Appeal against the refusal by LPA of application No 20/01844/FUL for Planning Permission to form a roof terrace with glass balustrade and access hatch.

Application for Listed Building Consent 20/01845/LBC At 37 Manor Place, Edinburgh, EH3 7EB Form a roof terrace with glass balustrade and access hatch.

The proposed roof terrace and associated works fail to preserve the listed building and its setting and have an adverse impact on the character and appearance of the conservation area.

Drawing Title
ROOF PLAN
EXTERIOR

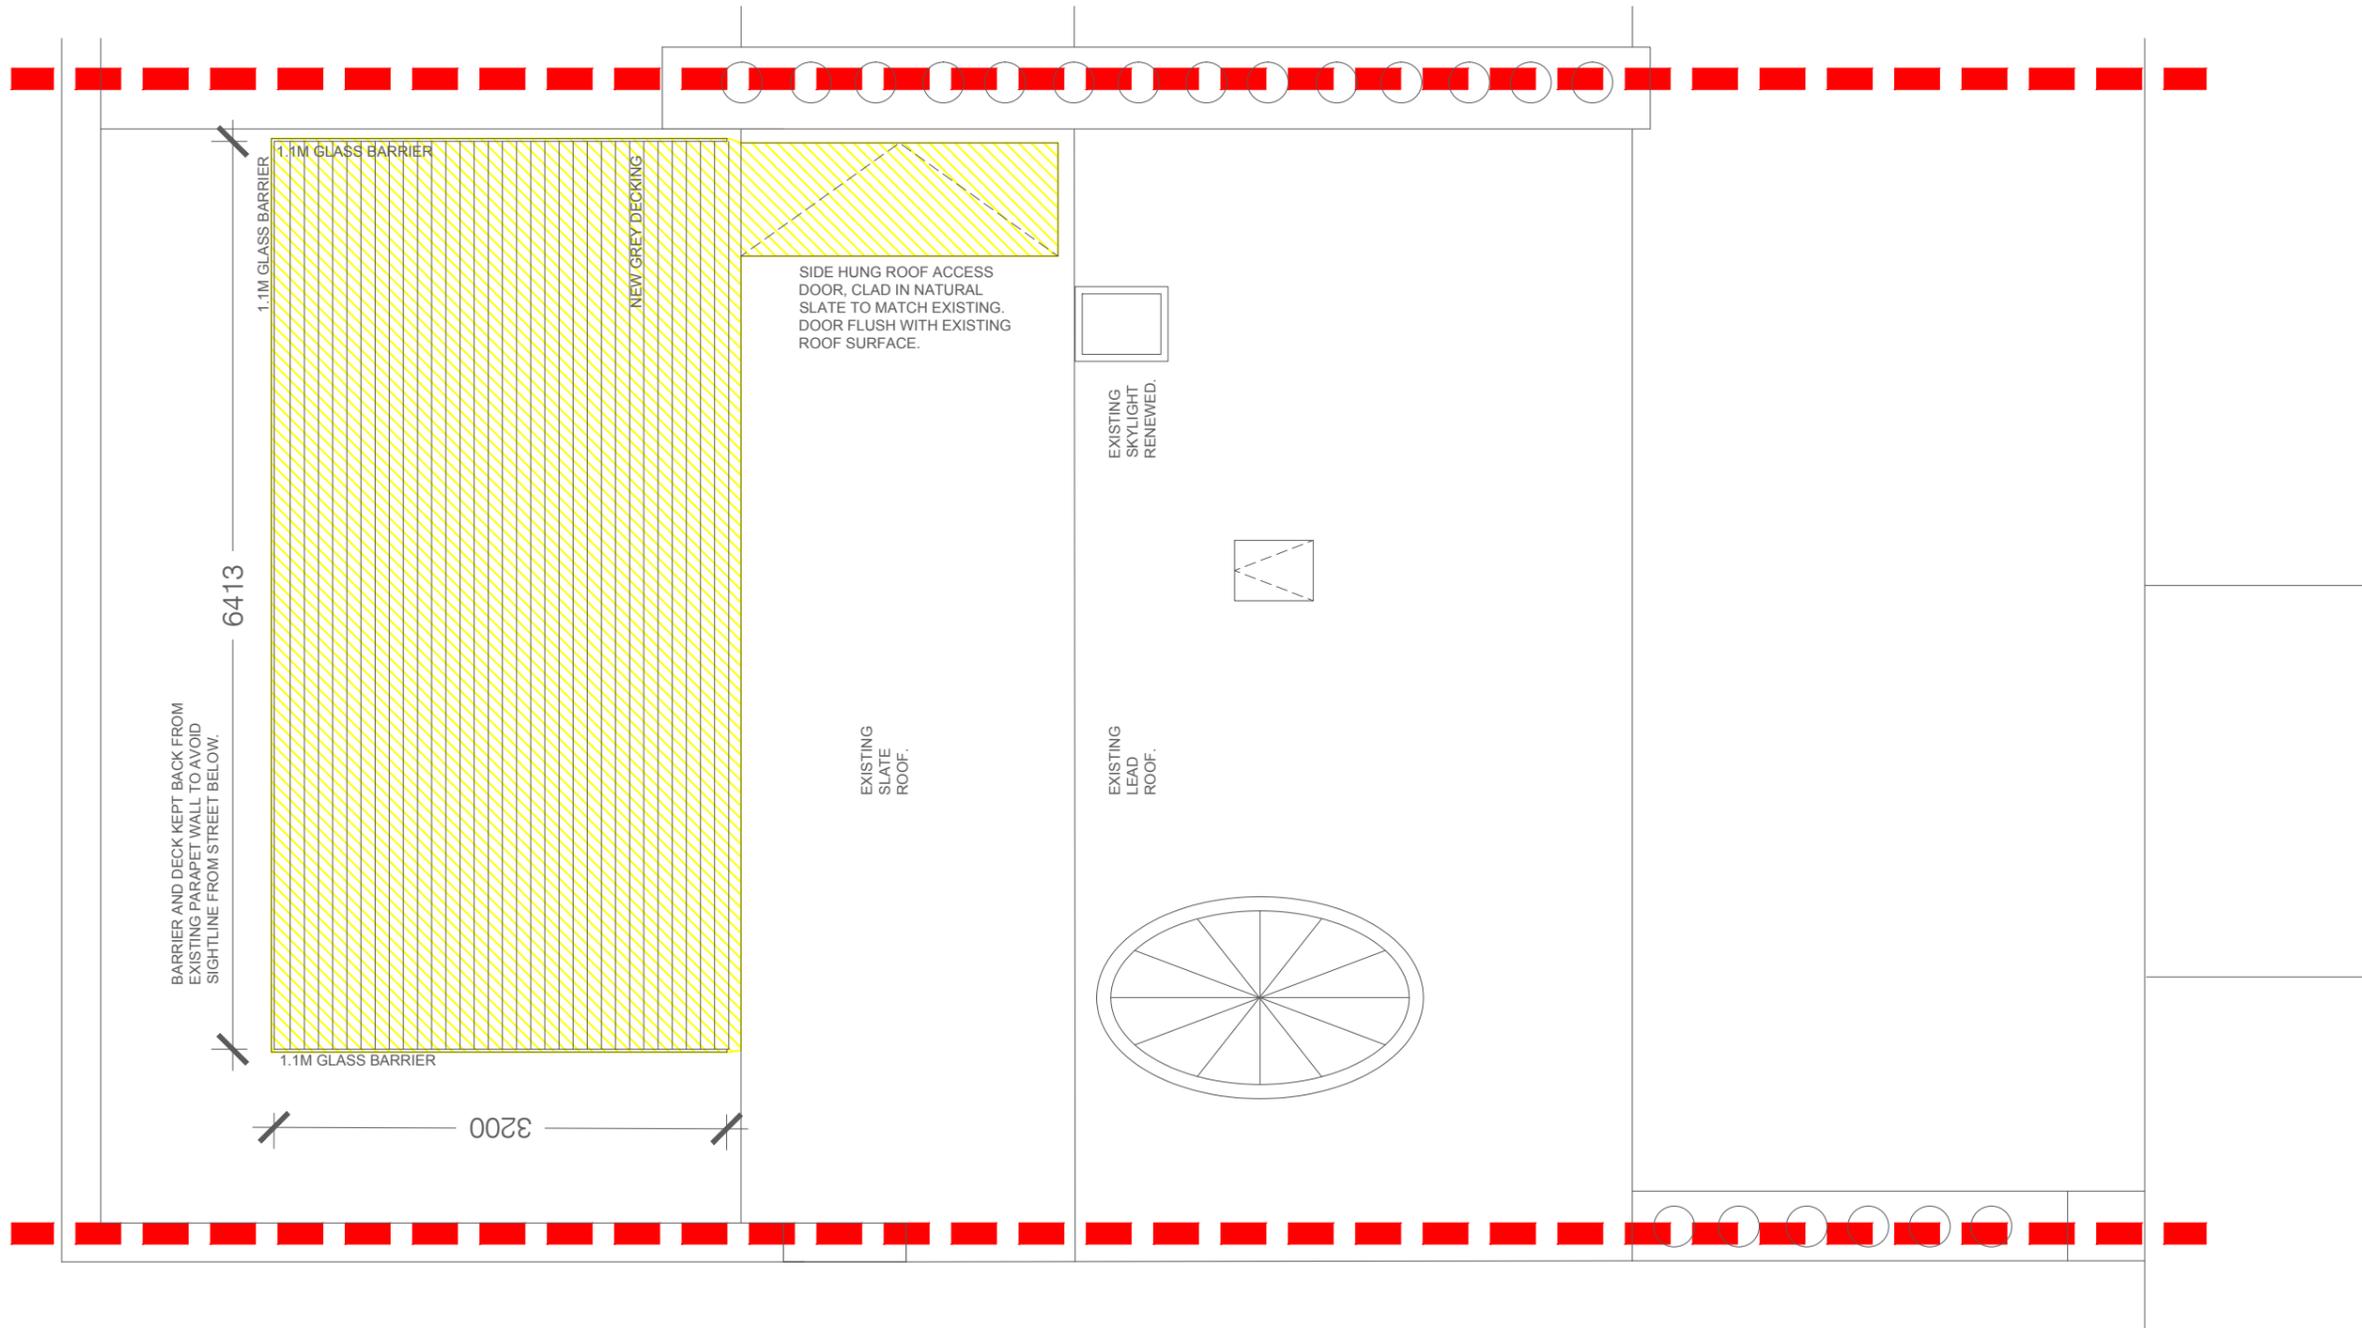
The roof form in this case is quite distinctive with an almost flat section to the front behind the stone balustrade and then a pitch further back. The proposed roof terrace would be a discordant feature creating a level of intervention in the front roof area that is not characteristic of the building and surrounding similar buildings in this largely uniform terrace. The extent of glass barriers, decking and large access hatch is at odds with the roofscape of the building and its functionality and would fundamentally change the character of the roof and an important part of the building's special interest. The

4.4.1 The roof deck will not change the nature of the flat roof section as the existing felt covering will remain intact with the new deck merely being positioned over it. However, the extent of deck covering has been scaled back from the original proposal, with the footprint reduced from 27.5 sq. m. to 20.5 sq. m. It is also proposed to be set back further from the
